**Planning & Strategy Committee**

**Title | Taitara: Recommendation to Accept the Private Plan Change request to Chapter 47 (Proposed District Plan) The Hills Resort Zone of the Proposed District Plan**

### **Proposed Private Plan Application: The Hills Response to Request for Further Information**

**Photograph 5: Walkway Alongside McDonnell Road**

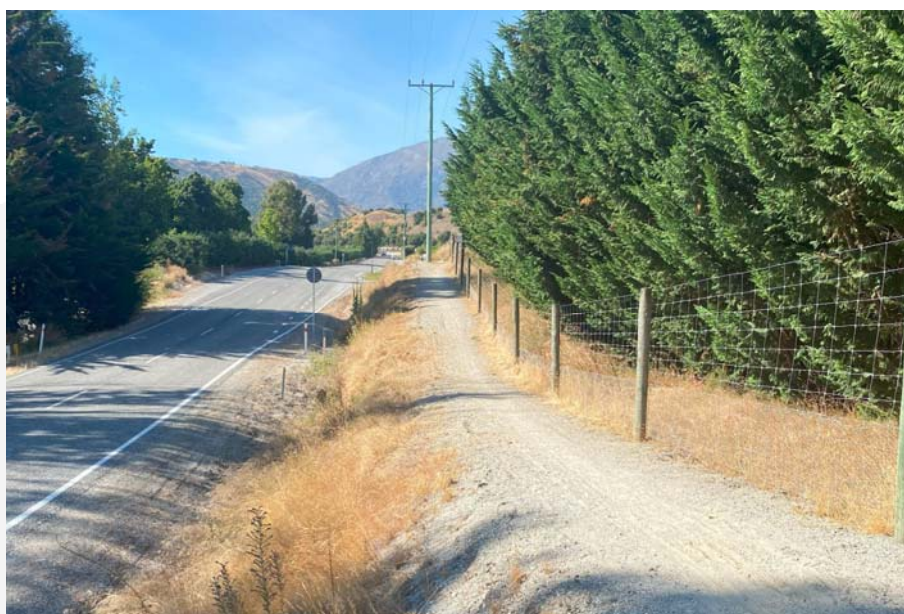
***Matter 18: Please identify any adverse effects on the Trail users experience and whether the existing indicative entry point onto McDonnell Road is more appropriate from both a safety perspective and a user experience perspective***

We are unable to comment on the 'experience' of a Trail user, but we note that an email from the Queenstown Trails Trust dated 7 February 2025 set out that in their opinion, the user experience was better under the proposed trail entry point to McDonnell Road location, as compared with the entry point shown on the operative zone Structure Plan.

We have visited the location of the operative and proposed trail entry points to McDonnell Road and note that both locations are very similar. Importantly, both connect onto an existing gravelled walkway that in parts is elevated above the level of the adjacent roadway.

Figure 19-1. Excerpt of the proposed Structure Plan with the Indicative Trail, and orange shape identifying the diversion of the Trail through 113 Hogans Gully Road and realigned access onto McDonnell Road adjacent to the Arrowtown Retirement Village.

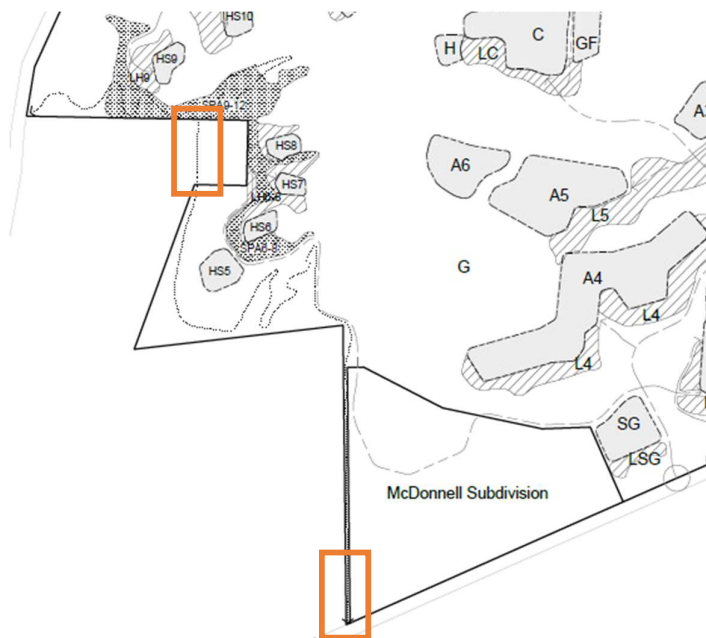
- 18. Please identify any adverse effects on the Trail users experience and whether the existing indicative entry point onto McDonnell Road is more appropriate from both a safety perspective and a user experience perspective.
- 19. Part of the proposed indicative Trail is located outside the THRZ and Structure Plan Area where it crosses in front of 113 Hogans Gully Road which is zoned Wakatipu Basin Rural Amenity Zone. Can you identify any impediments to subdivision and development (i.e. in the PDP provisions) of part of the THRZ Structure Plan area applying to a zone other than THRZ?

**Figure 20-3.** Excerpt of Plan Change Document 5 – Appendix 3. Red mark-up illustrating the proposed amendments.

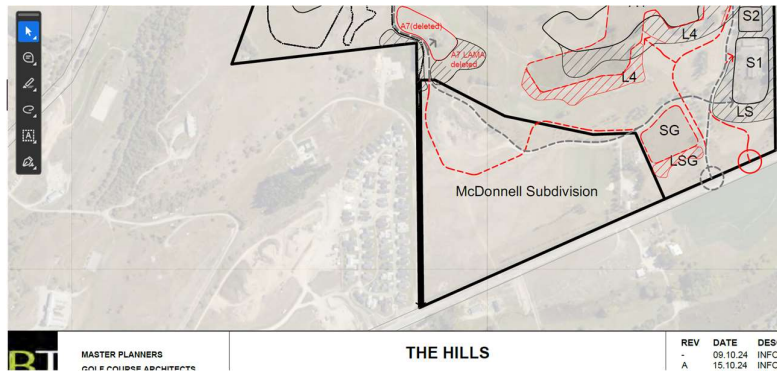
Figures 1-5 below indicate that a part of the proposed amendment to the Structure Plan proposing a road from McDonnell Road (via the existing access) to Homesites 5-8 road appear to be located within the adjoining Site zoned Wakatipu Basin Lifestyle Precinct, on the property legally described as Lot 2 Deposited Plan 392663.

The proposed new road access appears to encroach into the adjoining Wakatipu Basin Lifestyle Precinct zoning.

**Figure 20-5.** Excerpt of Plan Change Document 2 Proposed Structure Plan (Clean Version) showing the proposed road into what is understood to be Wakatipu Basin Lifestyle Precinct zoning.

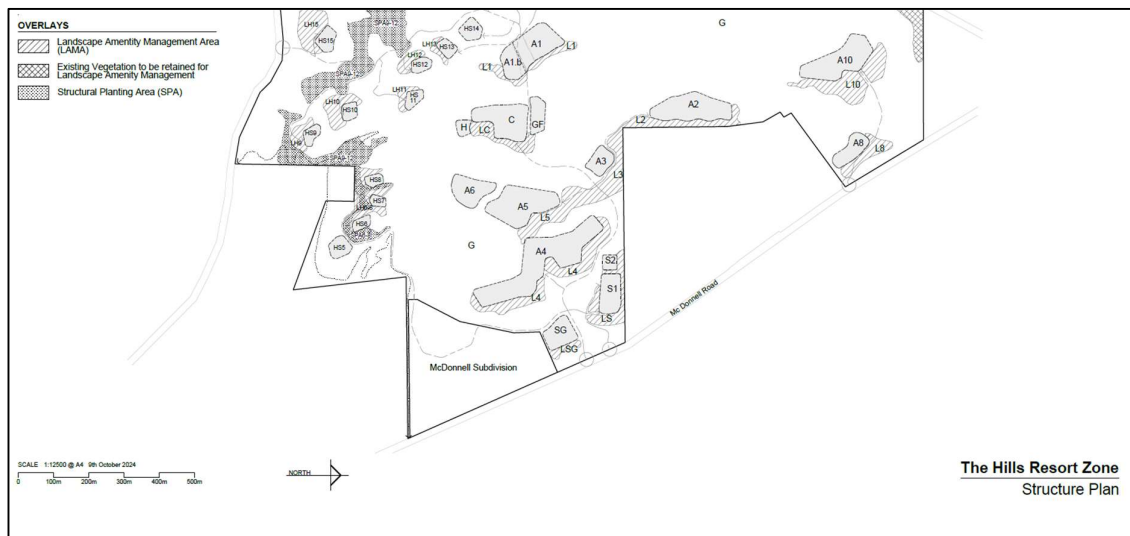
Note that the solid black line surrounding the area titled ‘McDonnell Subdivision’ does not appear to adhere to the existing cadastral boundaries nor the existing The Hills Resorts Zone Structure Plan.
